First Revision No. 26-NFPA 79-2022 [Detail]

First Revision No. 49-NFPA 79-2022 [New Section after 1.6]

Figure A.3.3.47 Available Fault Current.

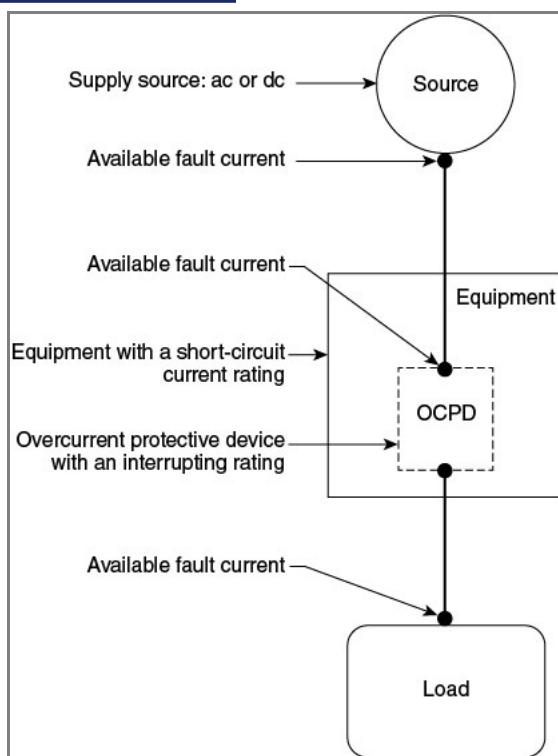
A short circuit can occur during abnormal conditions such as a fault between circuit conductors or a ground fault. See [Figure A.3.3.47](#).

Committee Statement: Adding Figure A.3.3.47.

Figure D.1(e) Elementary Schematic.

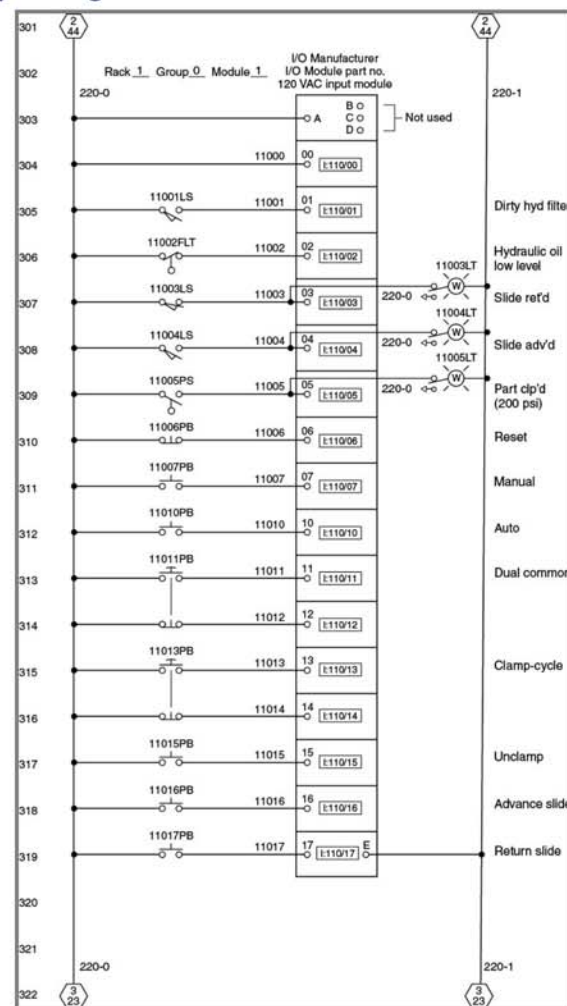
In Figure D.1(e) the word "conduit" is being changed to "raceway" to be consistent with the change made in 5.1.13.2
